Kjeller: 10th November 1982 Information No: 821110

Product: TR 2000 series

CHANGE TO NEW IC-CIRCUIT

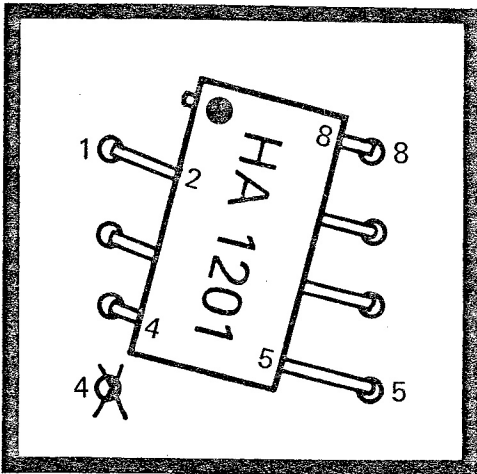
Circuit UA703HC is no longer available from our Spare Parts Department. This IC-circuit is replaced by HA1201, part No. 417824 (U201 and U202).

When the IC-circuit has to be changed to HA1201, the following must be done:

Cut off leg No. 1 on the IC-circuit.

Put the legs No. 5-8 into the holes 5-8.

Then turn the circuit slightly (see figure) so that hole No. 4 in the PC-board is not used and enter the three legs No. 2-4 as shown in the figure.
